Value Engineering Study for the New Woodland High School

RE: New High School Value Engineering Study – Final Report

WOODLAND SCHOOL DISTRICT New High School Value Engineering Implementation Plan

ITEM A-2: Add Storage Rooms off Commons

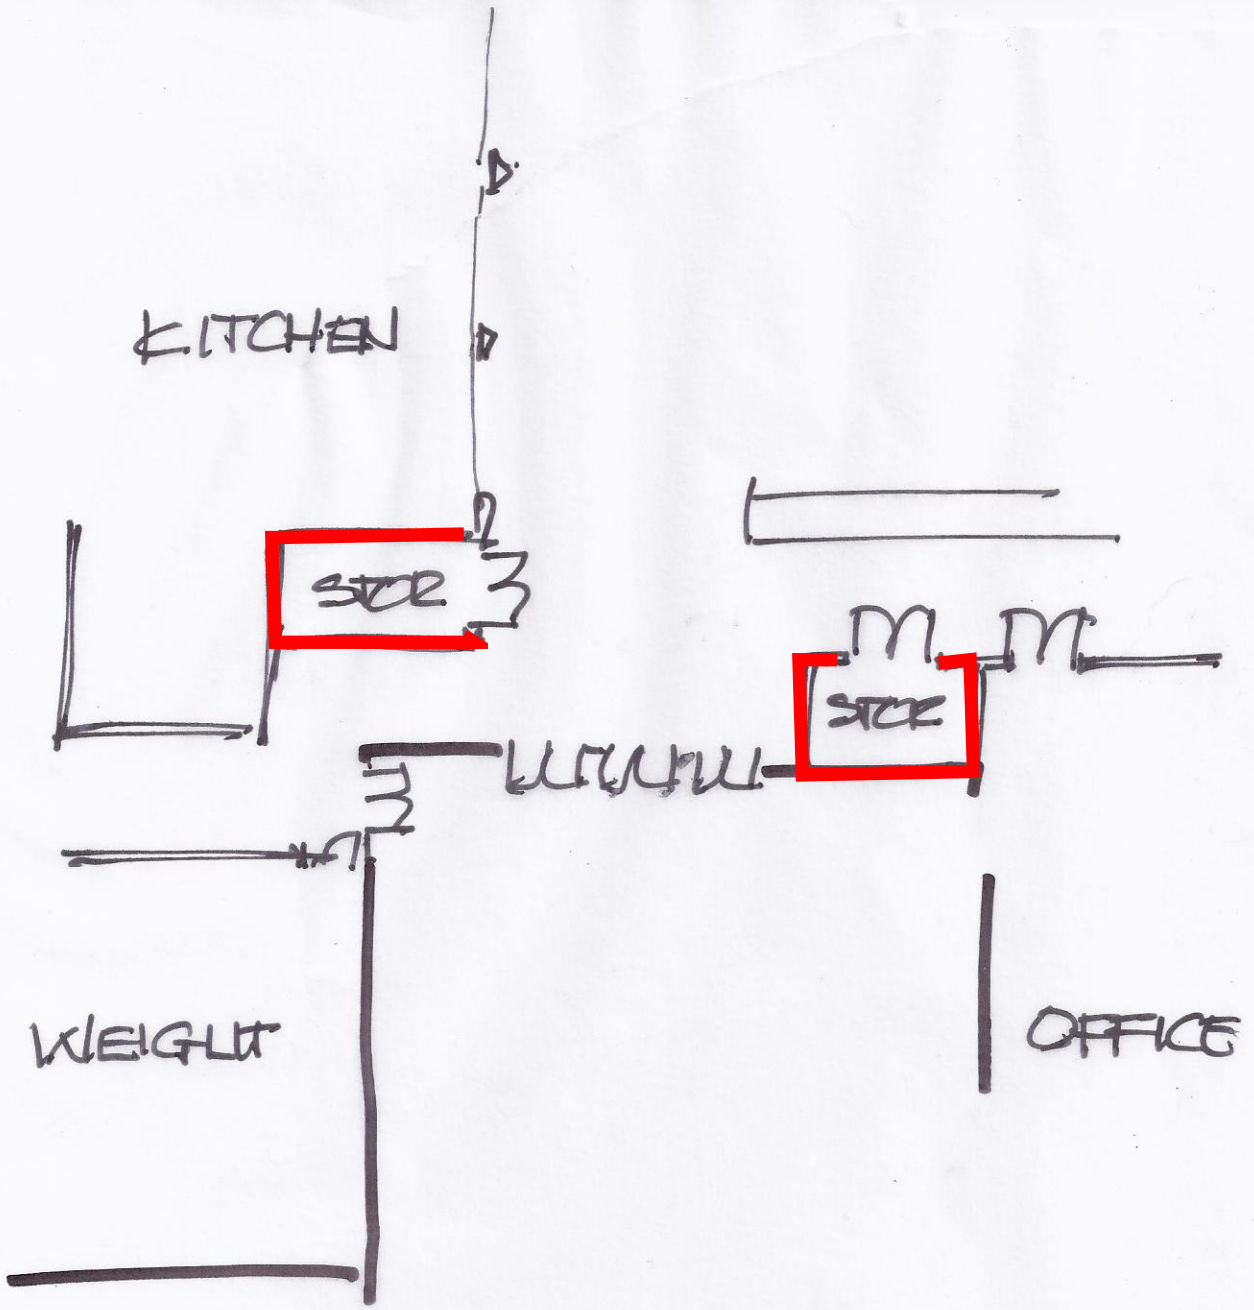
A-2	A2.01	Add storage rooms off commons per attached sketch.	No storage provide for storing dining furniture during performances		REJECT: Although we agree that having storage area for tables and chairs would be desirable, this idea was evaluated by the District during Schematic Design and discarded.	(24,000)

ITEM-3B: Depress Commons Floor in Tiers ILO Telescoping Seating - Plan

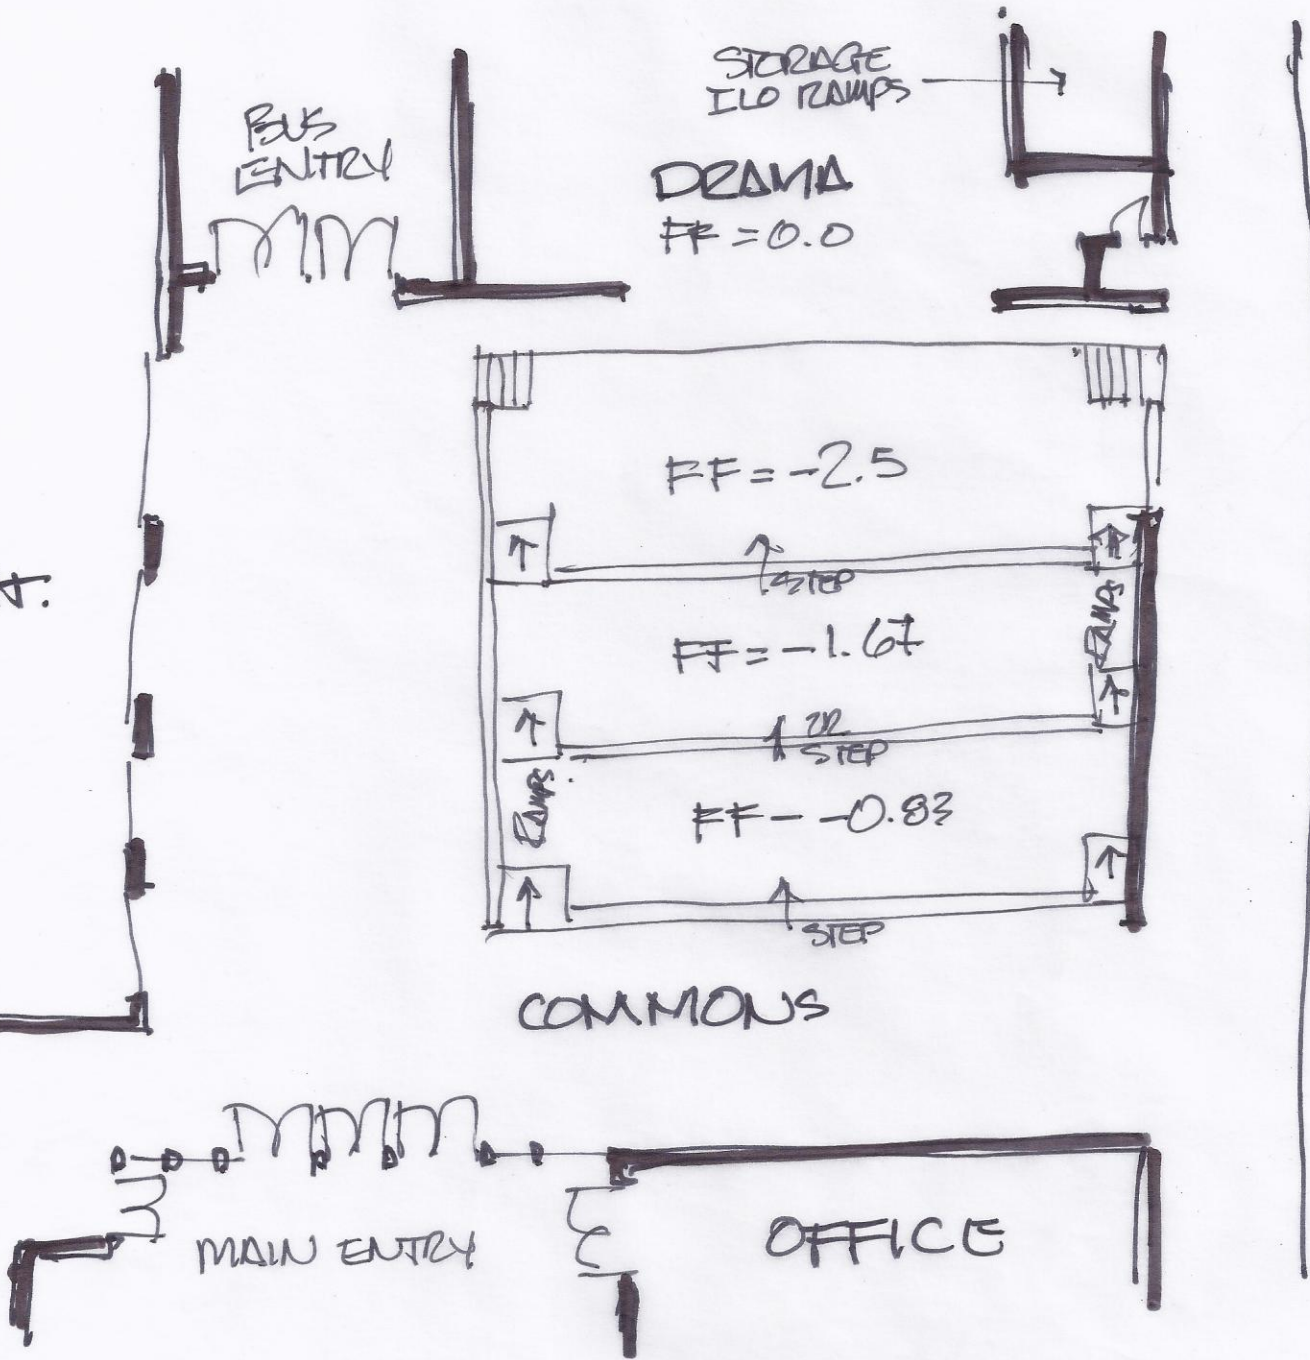
A-3B	A2.01	Depress commons floor in tiers ILO telescoping seating & drop Drama/Choir to main floor level per attached sketch	Allows better sight lines, dining tables and or seating on each tier.		<p>REJECT: One of the primary goals of this project is to create flexible space. The Commons is a prime example of that intent in that it will serve a variety of uses. Creating a tiered floor system however would significantly impair its ability to function in modes other than performance. It would also create vertical breaks in the floor that, although not large, would present a tripping/falling hazard. We believe that the cost to create the tiered floor would be much higher than the VE team is suggesting so the savings would be significantly less than proposed.</p>	(277,000)
